**WHITE LAKE TOWNSHIP  
ZONING BOARD OF APPEALS**

**REPORT OF THE  
COMMUNITY DEVELOPMENT DEPARTMENT**

**Location:** 4925 Ormond Road  
White Lake, MI 48383

Leo Huantes, the applicant, on behalf of property owner Sonny G Investments LLC, is proposing to construct a 24-foot by 25-foot attached garage (600 square feet).

105 N. Washington St.  
Oxford, Michigan 48371  
STAKED SURVEY

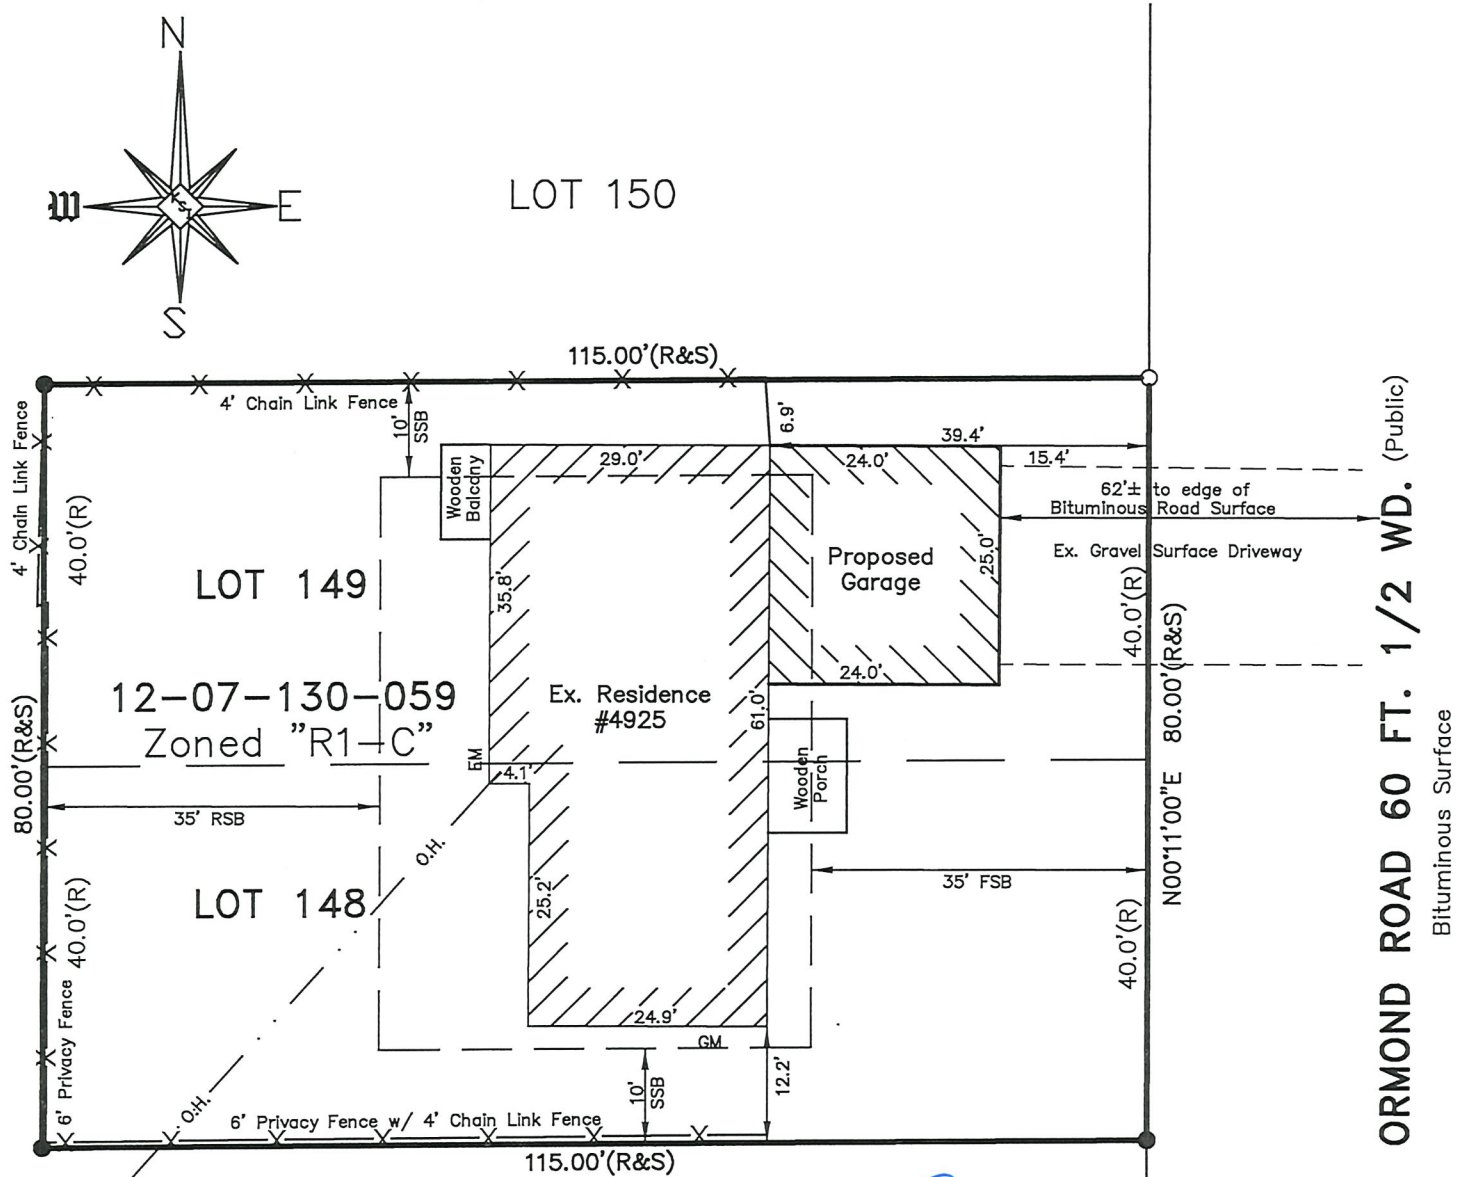
The existing house was built in 1970 and is nonconforming because it is located 6.9 feet from the north side property line. A minimum 10-foot side yard setback is required in the R1-D zoning district. The parcel is also nonconforming due to a 2,800 square foot deficiency in lot area; in the R1-D zoning district the minimum lot size requirement is 12,000 square feet. The proposed garage addition at the front of the house would be located 6.9 feet from the north side lot line and 15.4 feet from the front property line; therefore, the applicant is requesting to encroach 3.1 feet into the side yard setback and 14.6 feet into the front yard setback (30 feet in the R1-D zoning district). Note the architectural plans show the garage would be 25'-3" wide and the survey shows the garage would be 25 feet wide.

- The Applicant shall obtain all necessary permits from the White Lake Township Building Department.
- The survey and/or architectural plans shall be revised to provide consistent garage dimensions.
- A foundation certificate shall be required prior to the backfill inspection by the Building Department.
- An as-built survey shall be required to verify the approved setbacks.

Plot Plan View

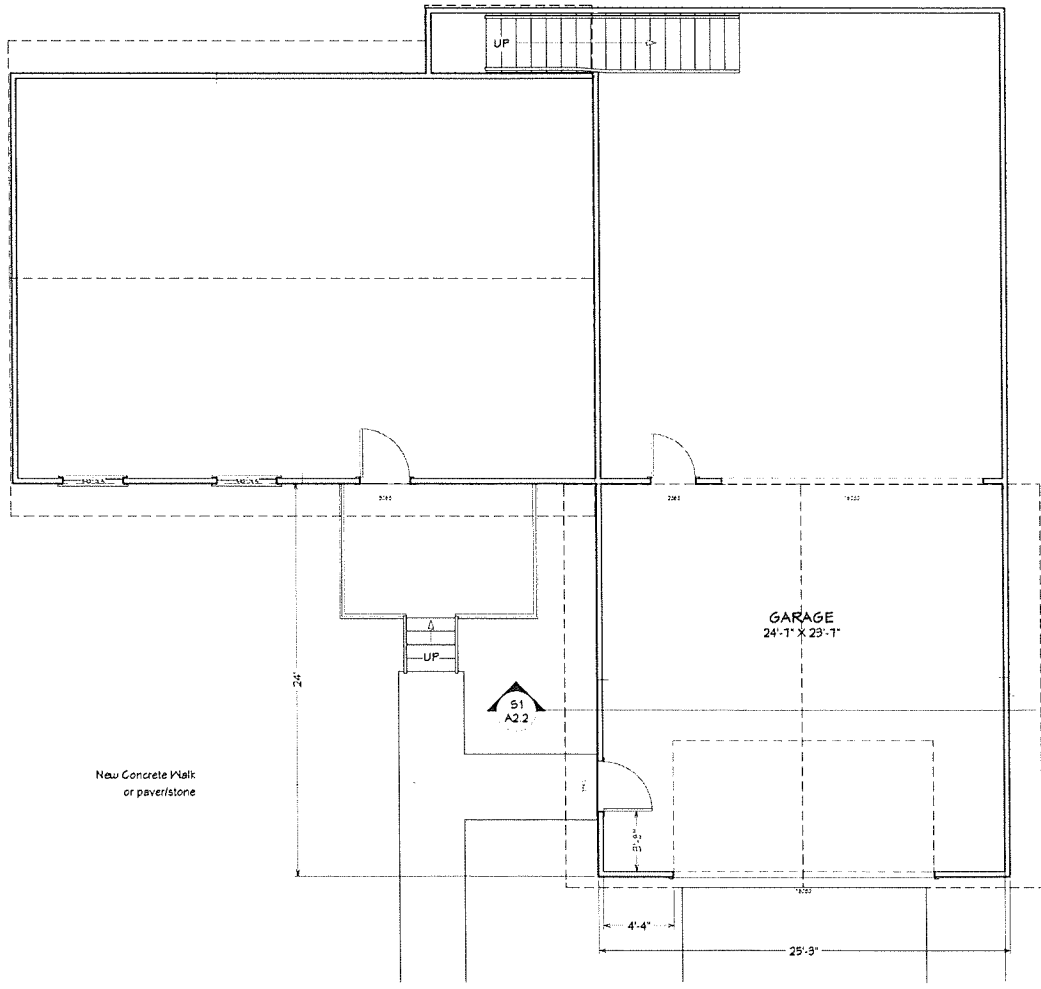
Based on the submitted plans and scaled aerial views of the property, the proposed residential addition does not satisfy the White Lake Township Clear Zoning Ordinance for R1-D zoning district.

The existing structure is legal non-conforming. The 9,191 sq ft lot contains a residential structure; having approximately a 40 ft front yard setback and 6 ft side yard setback on the north side. The proposed addition would maintain the non-conformity on the side yard and create an additional 14 ft non-conformity to the front yard setback. The maximum lot coverage will also be considered as the addition will most likely put the lot coverage over 20%.

Approval of the building plans would be subject to a variance to the schedule of regulations, Article 7 of the White Lake Township Clear Zoning Ordinance. To be eligible for the December 9<sup>th</sup> Zoning Board of Appeals (ZBA) meeting, application must be submitted to the White Lake Township Planning Department no later than November 4<sup>th</sup> at 4:30 PM. **A certified boundary and location survey will be required by the ZBA.** The Planning Department can be reached at (248)698-3300, ext. 5
